Accessibility Review Report – DA

Project Title: Wollongong Private Hospital Extension
360-368 Crown Street & 15-23 Urunga Parade, Wollongong

Job Number: 24465

Report Version: 24465_ADR_DA_v1.4

Figure 1 – Ground Floor Plan Extract

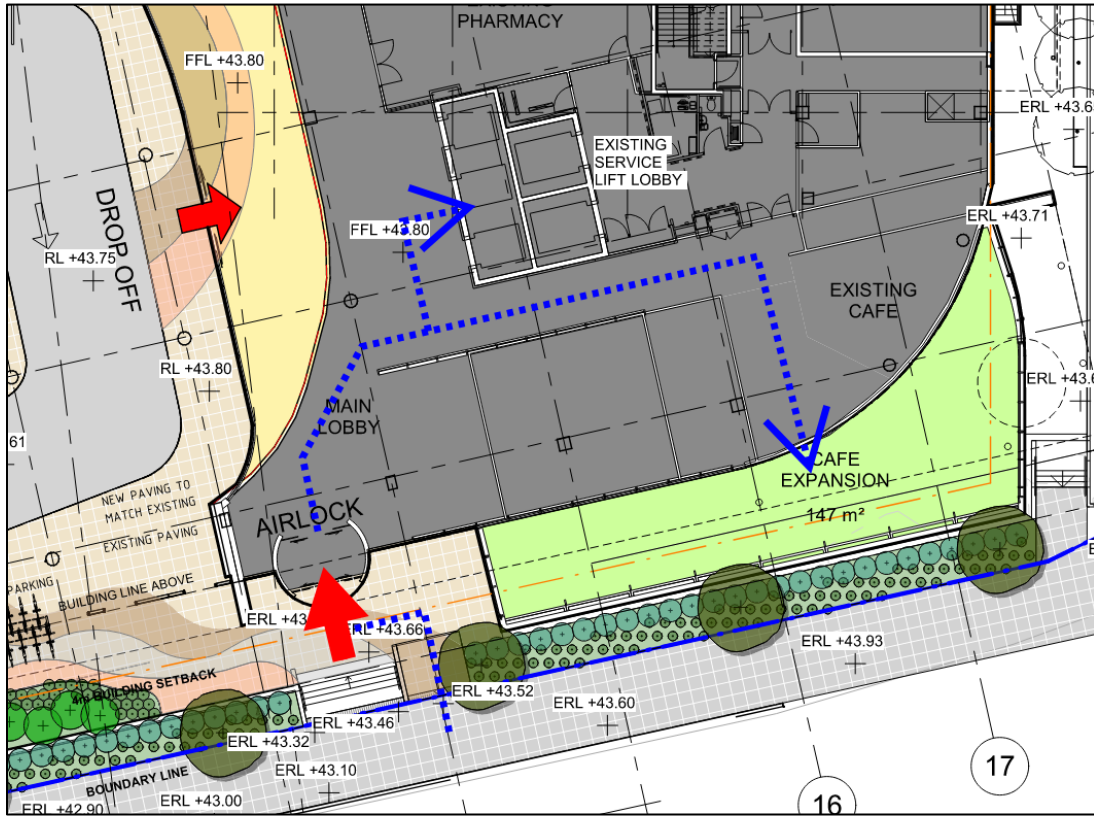
Highlighted Green – New works within existing building on Ground Floor

Red Arrow – Location of Principal Pedestrian Entry to the Building Part

Blue Arrow – Direction of the “affected part” located on Ground Floor between the Existing Entry & New works/
lifts to Level 1

Figure 2 – First Floor Plan Extract

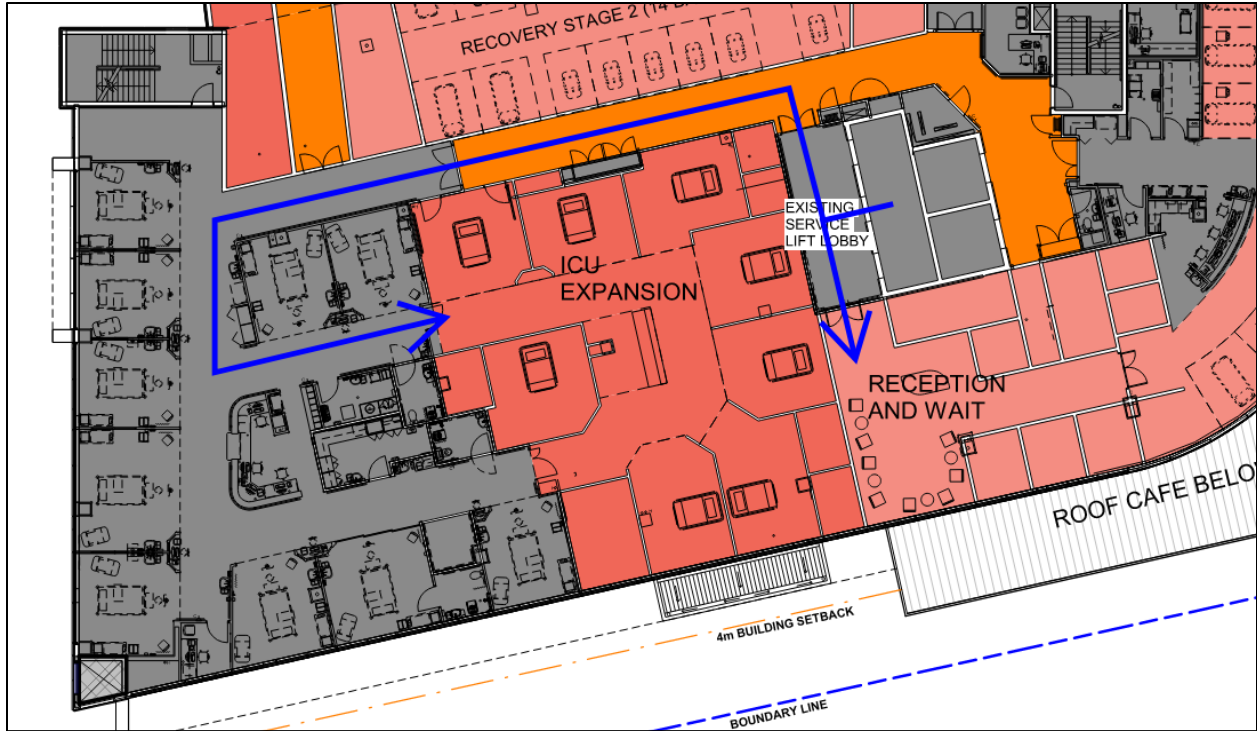
Highlighted Green – New works within existing building on Level 1

Highlighted Orange – Part of Level 1 expansion

Blue Arrow – Direction of the “affected part” located on Level 1 between the expansion & refurbishment

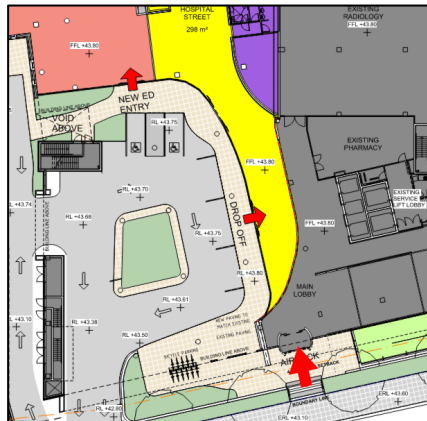
DtS Provision	Comment(s)/Recommendation(s)	Status
<p>An accessway must be provided to a building required to be accessible –</p> <ul style="list-style-type: none"> • from the main points of pedestrian entry at the allotment boundary; and • from another accessible building connected by a pedestrian link; and • from any required accessible carparking space on the allotment. <p>In a building required to be accessible, an accessway must be provided through the principal pedestrian entrance, and –</p> <ul style="list-style-type: none"> • through not less than 50% of all pedestrian entrances including the principal pedestrian entrance; and • in a building with a floor area more than 500m², a pedestrian entrance which is not accessible must not be located more than 50m from an accessible pedestrian entrance. <p>except for pedestrian entrances serving only areas exempted by D4D5.</p>	<p>As the proposed works are within the existing building, some of the provisions in D4D3 are not applied as there are no new associated pedestrian accessways proposed under this approval.</p> <p><u>Allotment Boundary</u></p> <p>The building is provided with multiple pathways off the allotment boundary. These include the following:</p> <ul style="list-style-type: none"> • <u>Hospital – Crown Street:</u> <p>From the Crown Street building frontage there is stairway and walkway access.</p> <p>Refer to Table D4D4 for an assessment on the ramps leading from the allotment boundary to the building.</p> <p>Further review of accessways will occur at detail design stage.</p> <ul style="list-style-type: none"> • <u>Hospital – Urunga Parade:</u> <p>From the Urunga Parade building frontage there are multiple pedestrian openings from the street.</p> <p>Refer to Table D4D4 for an assessment on the ramps leading from the allotment boundary to the building.</p> <p>Further review of accessways will occur at detail design stage.</p> <ul style="list-style-type: none"> • <u>Existing Dwellings (Class 5) – Crown Street:</u> <p>Existing houses are Classed 5 under the BCA, the new external pathway as identified red</p>	<p></p> <p>CoC</p>

in the figure below is achieve compliance with the requirements of AS1428.1-2021.

Due to a lack of information on the drawings including RL's and gradients a full assessment of this pathway is unable to be completed at this stage.

Design of this pathway will be further reviewed at detail design stage ensuring compliance with AS1428.1-2021 is met.

A lack of detail is currently provided regarding the external pathway between the accessible parking space and the 2x Class 5 buildings.

The external pathway is required to meet AS1428.1-2021.

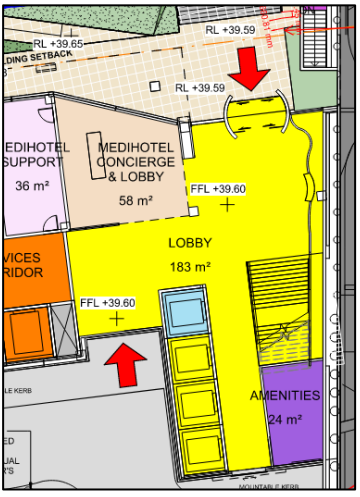
- **Hospital – Ground Floor:**

Multiple building entrances are indicated throughout the Ground Floor.

Automatic sliding doors are indicated at each entry point. Ensure a level landing is provided at each of the entry doorways.

Further review of entrances will occur at detail design stage.

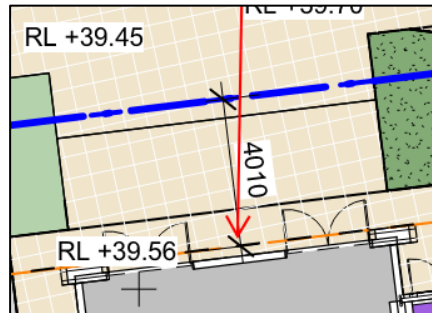
DtS Provision	Comment(s)/Recommendation(s)	Status
<p>In a building required to be accessible every ramp and stairway, except for ramps and stairways in areas exempted by D4D5, must comply with –</p> <ul style="list-style-type: none"> • for a ramp, except a fire-isolated ramp, Clause 7 of AS 1428.1; and 	<p>All non-fire-isolated ramps are required to comply with AS1428.1-2021.</p> <p>Drawings indicate a number of walkways (a gradient of 1:20 or shallower) as part of the works located on the Lower Ground Floor off Urunga Parade & Ground Floor off Crown Street.</p> <p><u>Detail Design:</u></p> <p>An external walkway at the Crown Street boundary indicates a walkway.</p> <p>Design, gradient and is to be no steeper than 1:20.</p>	<p>CoC & DD</p>

The following items will affect gradients:

- Clear width of the walkway (graded area), and
- Fall across Crown Street.

The gradient of the pathway is defined based on the worst case scenario.

Further review of this feature will occur at detail design stage.

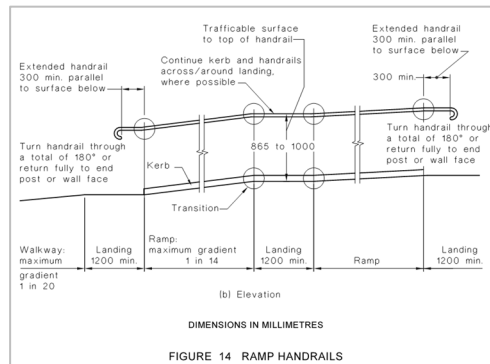
Upper landing of walkway in front of substation opening is required to achieve a minimum 1500mm clearance for a 90 degree turn.
